**REQUEST FOR ACTION
CHASKA PLANNING COMMISSION
APRIL 11, 2018**

Subject: Former Hot Spot and Michael's Cycles - Concept Plan

Case No.: PC No. 2018-10

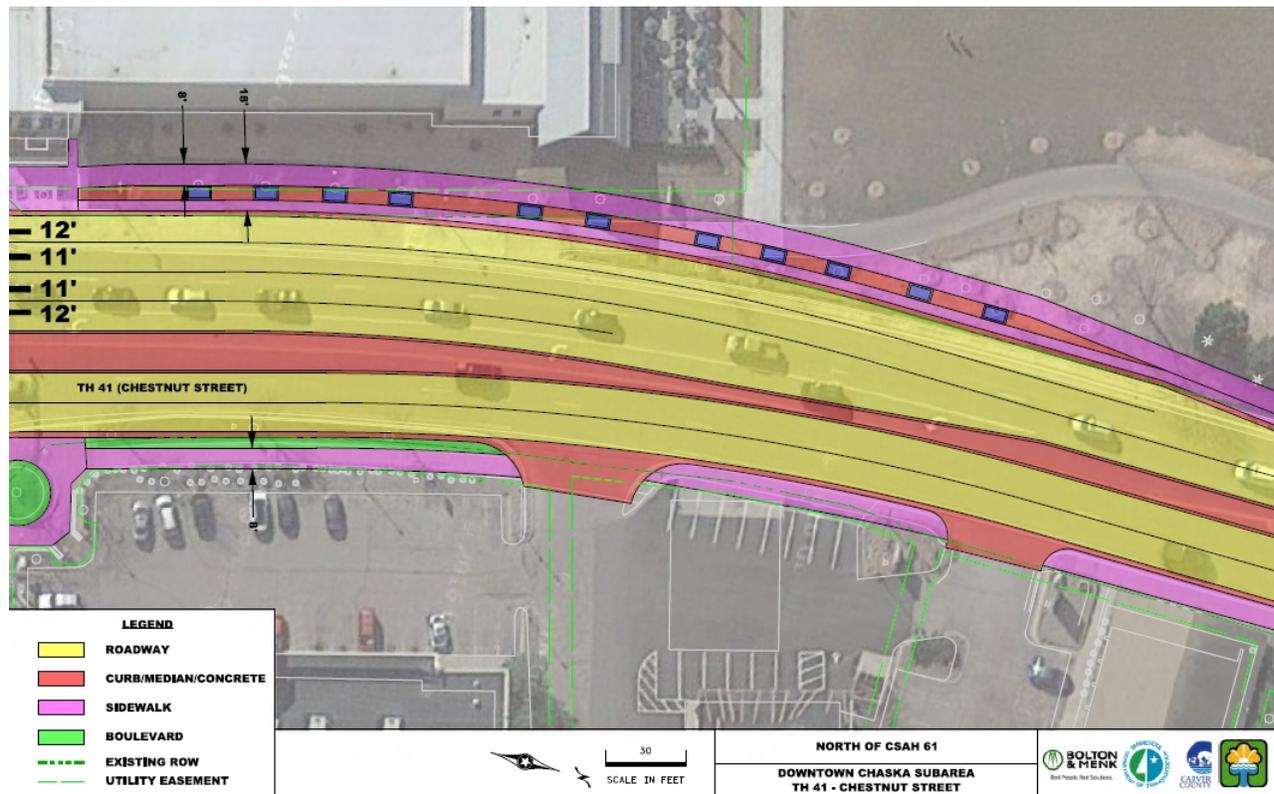
50 parking spaces are proposed as a part of this project. The following chart summarizes the overall parking demand on the site, based on the approximated sizes of the conceptual uses.

According to this table the applicant is not meeting the required amount of parking spaces needed for the use. Parking spaces will be provided on the west and south sides of the buildings. The proposed parking lot layout will provide adequate drive aisles and a more appropriate buffer between the road, sidewalk and parking.

The number of parking spaces is short by 4 spaces. Staff is confident that the applicant can provide a workable solution to meet parking counts. If not, then a parking summary will need to be provided that indicates the number proposed will work between all three buildings.
